# Product change notification (PCN)

<b>Title / short description</b>	Design update and voltage rating enhancement for UDK 4-MTK* products
<b>Affected article category</b>	Terminal blocks
<b>Change category</b>	Form and appearance, Characteristics
<b>Change number</b>	CBE250090-00
<b>Reason for PCN/PDN Revision</b>

## UDK 4-PE

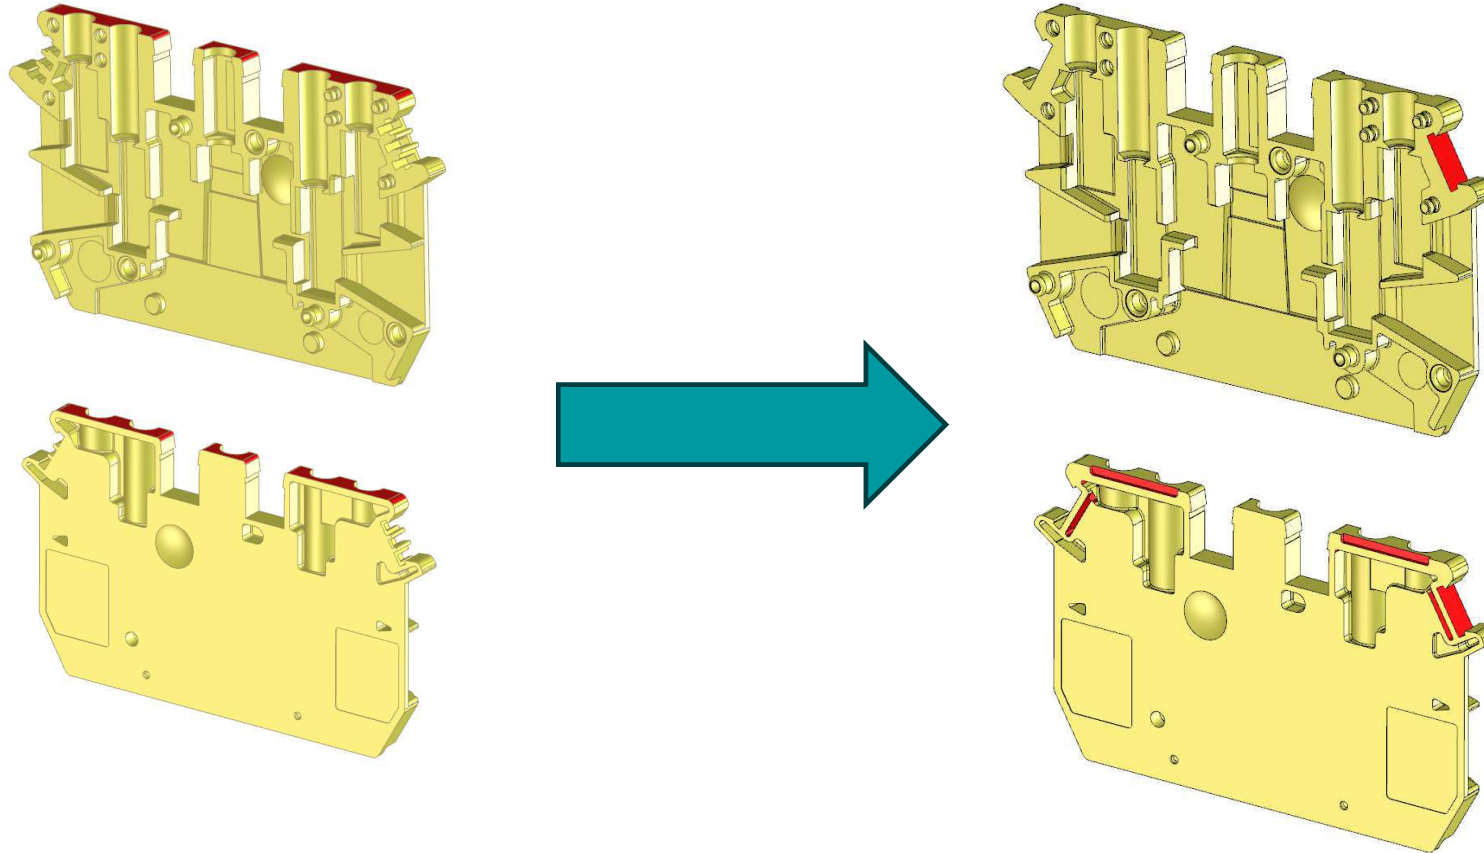
- Housing will be slightly adjusted to increase insulation distances, thereby allowing higher insulation voltages.
- Description fields on the housing will be updated to reflect the increased IEC nominal voltage, which will change from 630 V to 690 V.
- UL voltage ratings will be increased accordingly

Due to insulation#related design adjustments, the visual appearance of the housing will differ slightly from the previous version (see attachment).
